October 2nd, 2009

Re: California Energy Commission (Energy Commission)
Docket No. 09-IEP-1C: Written Workshop Comments
of Southern California Edison Company (SCE) the
2010 – 2020 Peak Demand & Energy Forecasts

**CHART 3 - CEC REVISED RESIDENTIAL FORECAST FOR SCE PLANNING AREA
1990 - 2008 HISTORICAL TREND OF MODELED AND RECORDED DIFFERENCES**

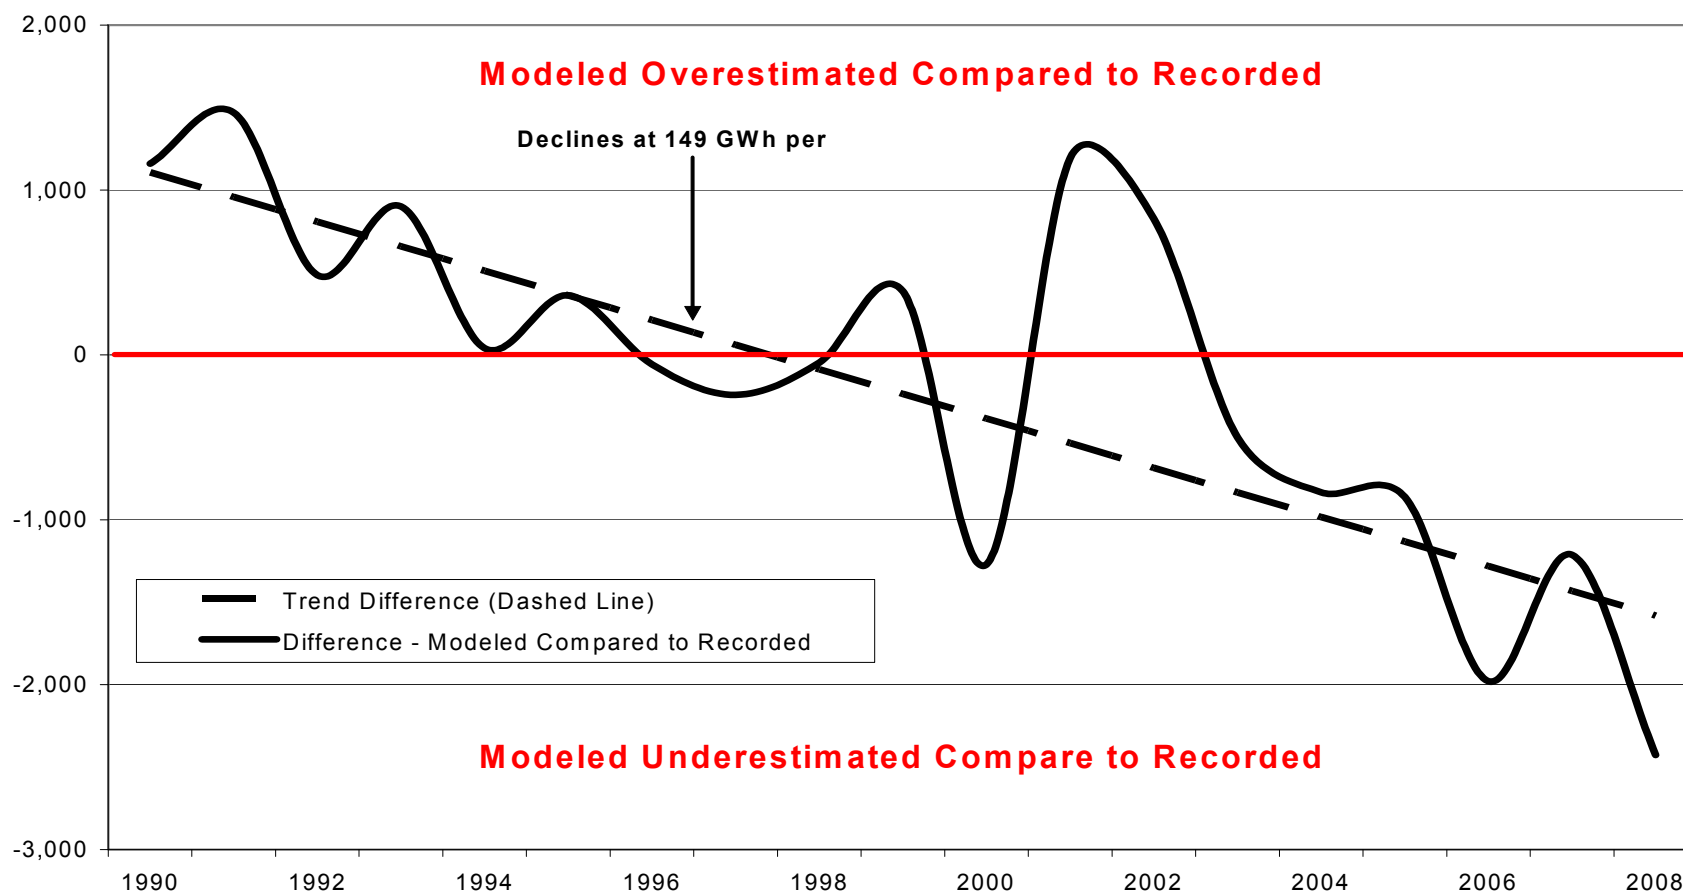
Chart 3 – A trend line (black dashed line) fitted to the difference between modeled and recorded consumption provides a measure of the increasing discrepancy between the forecast and recorded. The difference increases at an average rate of 149 Gigawatt-Hours (GWh) per year. Recorded consumption for the 1990 through 2008 grew 149 GWh faster than the model estimated. The effect on the forecast is shown in Chart 5.

**CHART 4 - CEC REVISED RESIDENTIAL FORECAST FOR SCE PLANNING AREA
HISTORICAL TREND OF DIFFERENCES EXTENDED THROUGH FORECAST PERIOD**

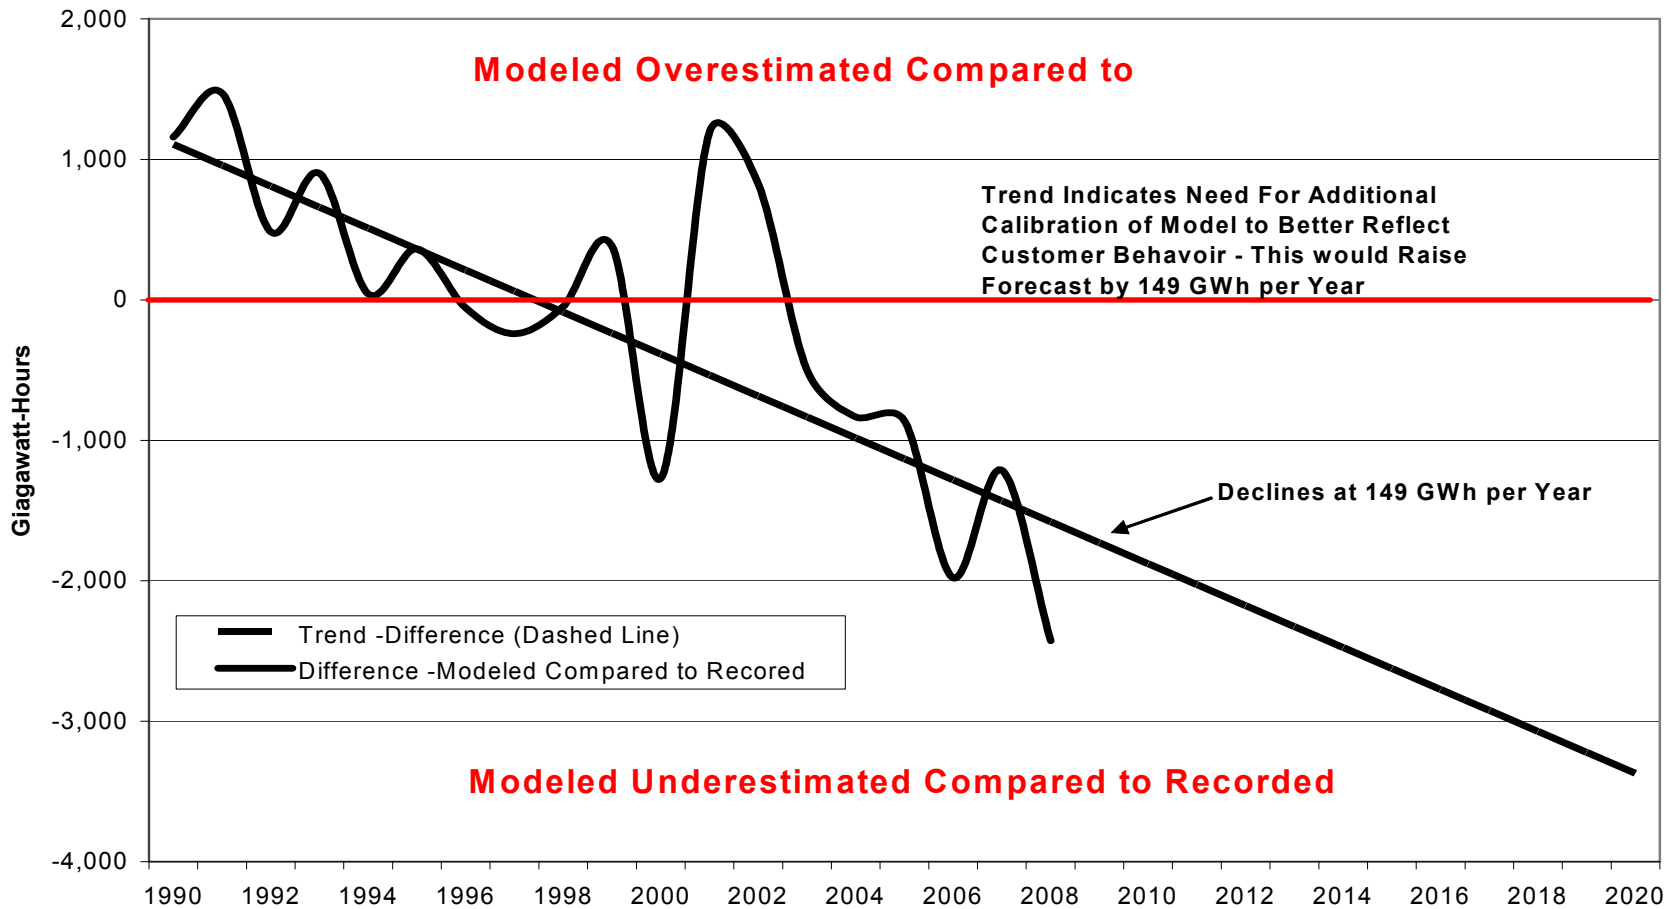
Chart 4 - The trend line is carried through 2020, the forecast period

**CHART 5 - CEC REVISED RESIDENTIAL CONSUMPTION FORECAST
FOR SCE PLANNING AREA
CEC UNCALIBRATED AND CALIBRATED FORECASTS**

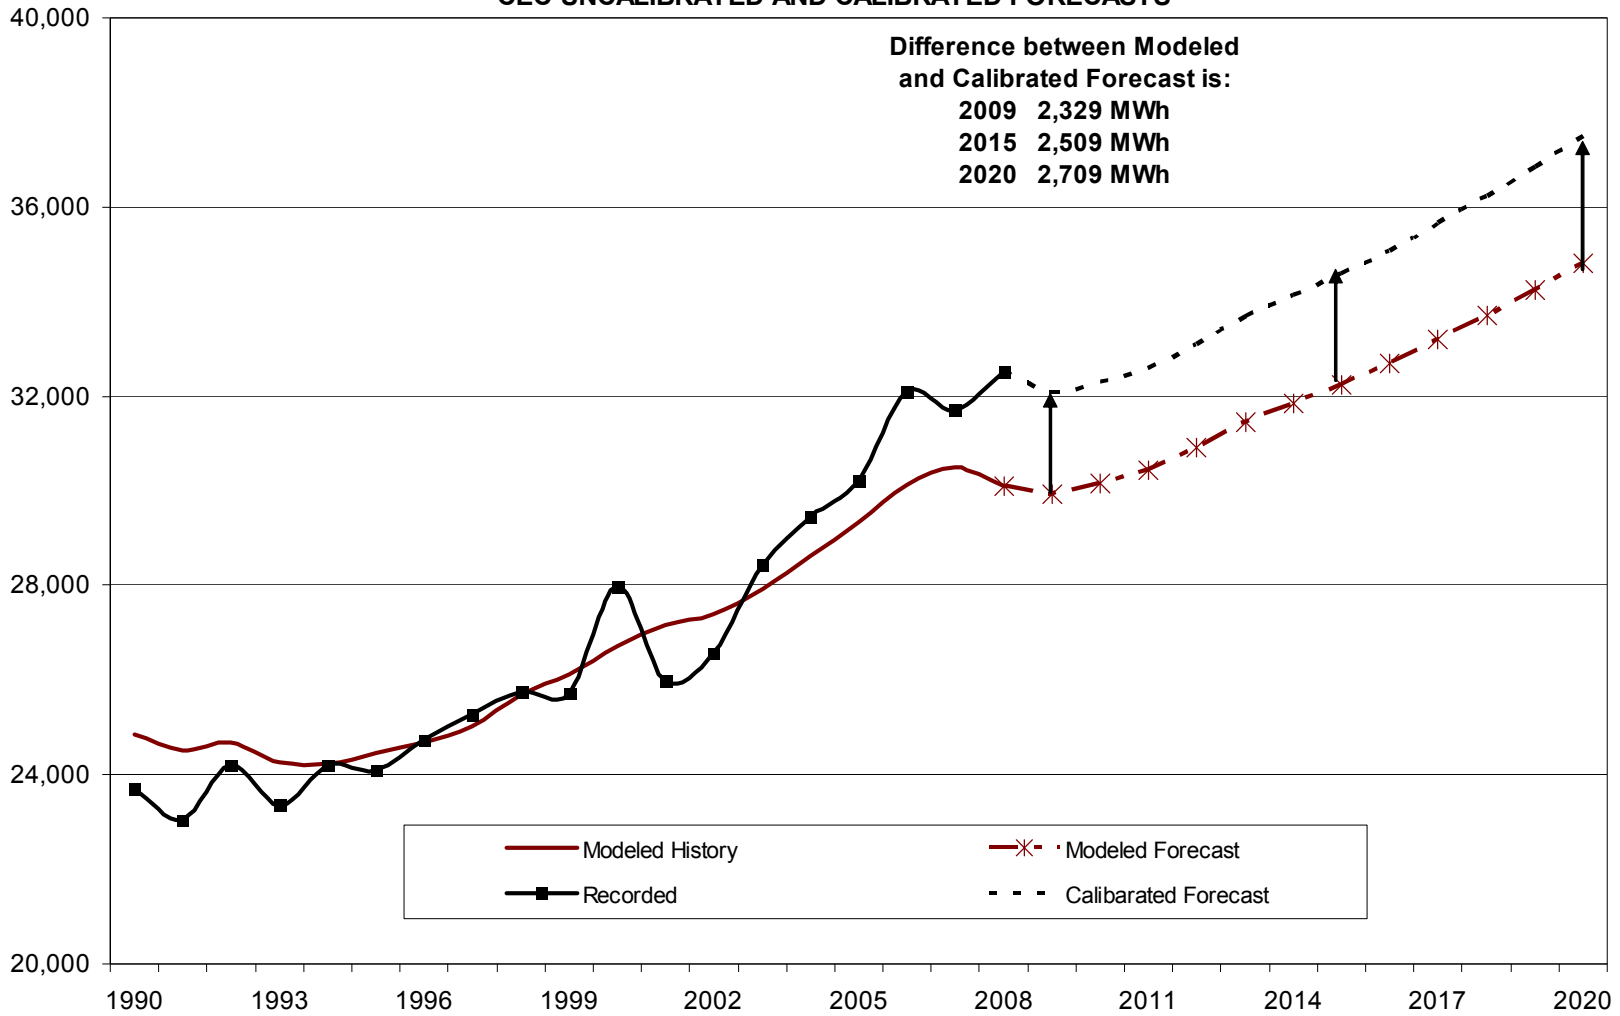
Chart 5 – Presents the Modeled and the Calibrated forecasts as published by CEC Staff and the calibration for selected years applied by CEC Staff.

**CHART 6 - CEC REVISED RESIDENTIAL CONSUMPTION FORECAST
FOR SCE PLANNING AREA
WITH RECOMMENDED TREND ADJUSTED CALIBRATION**

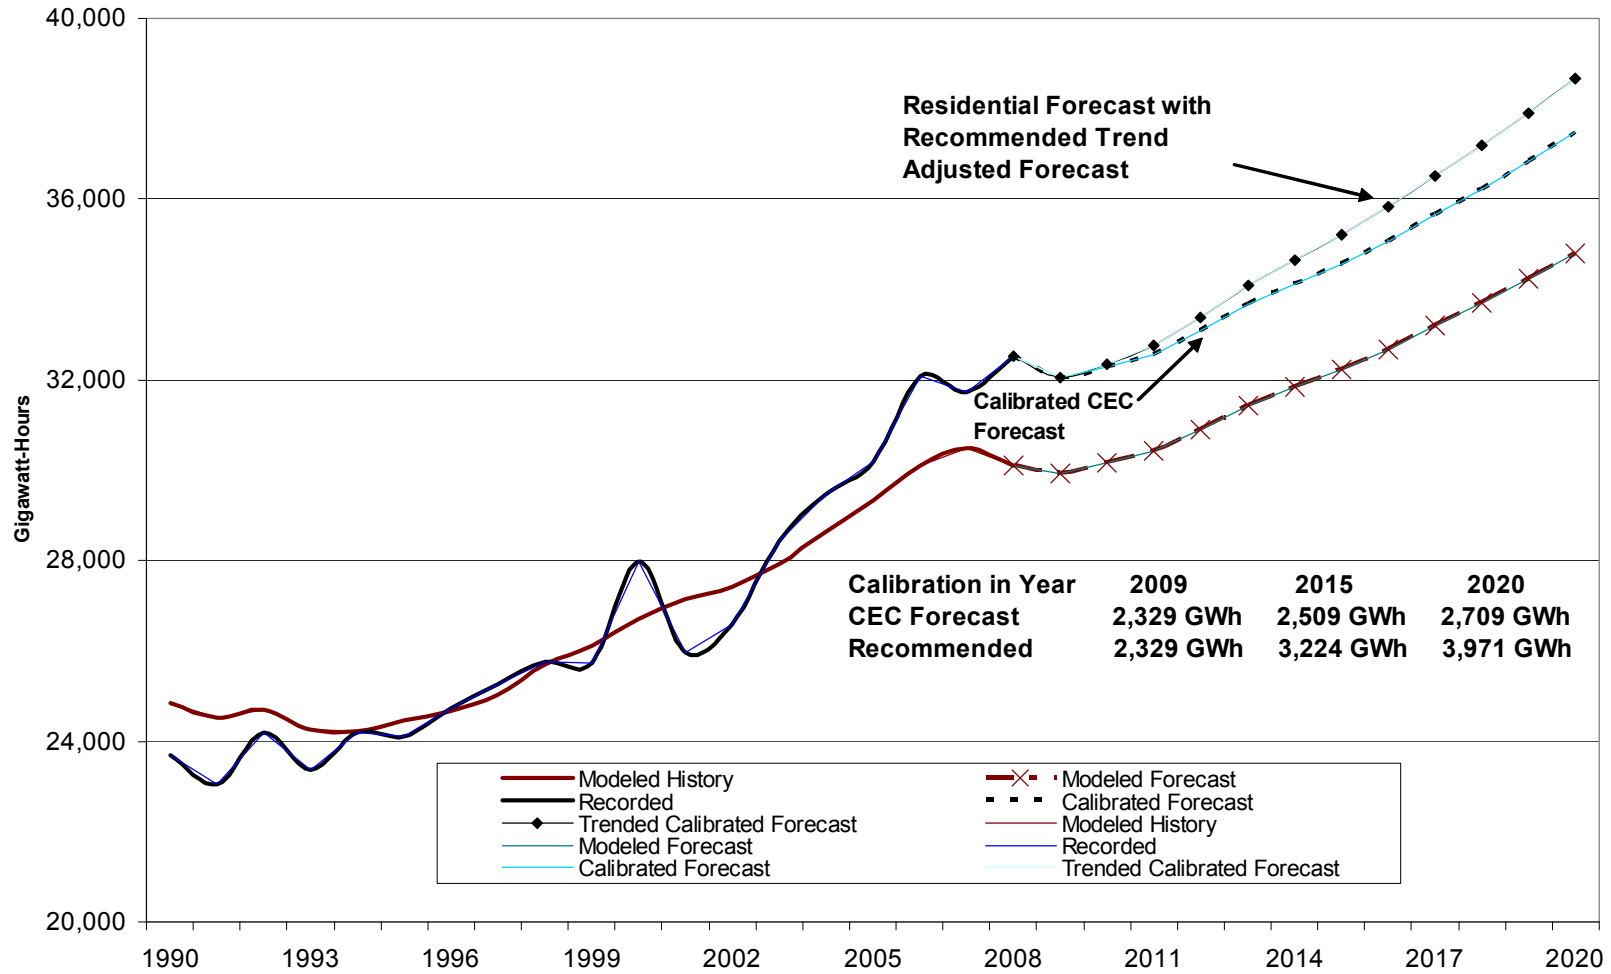
The situation is greater than just "after 2002", and an adjustment should be made to the residential model and forecast. Although Staff has calibrated the model output to match the recorded 2008 value as the starting point for the forecast, Staff has not adjusted for the fact that the residential model has a definite pattern of underestimating the growth in residential energy use for 1990-2008. Thus, the growth rate of the model also needs to be calibrated. SCE has calculated that this underestimate of the growth rate is about 150 GWh/year in the residential sector. Although further study may be able to attribute this 150 GWh/year to some specific end-use or to the income elasticity, the fastest way to adjust the model may be to add sufficient growth in GWh/year to the "miscellaneous" sector by 150 GWh/year, and thus closely match the recorded trend.

Whatever adjustment is made to the historical period should be made to the forecast period also. As a first estimate, this adjustment would raise the forecast for 2020 by about 1500 GWh or about 350 MW (assuming a 45% load factor), but other factors in the Staff model (e.g. price or income elasticity) may affect this result. SCE's graphical analysis of the need to calibrate the growth trend in the residential model is shown on the attached document.

Chart 6 – It is recommended the calibration used in the CEC Staff’s forecast include an additional 149 GWh per each year in the forecast period. The recommended calibration remedies the CEC Staff’s residential model’s tendency to underestimate growth. This can be accomplished by adding 149 GWh per year to the Miscellaneous End Use.
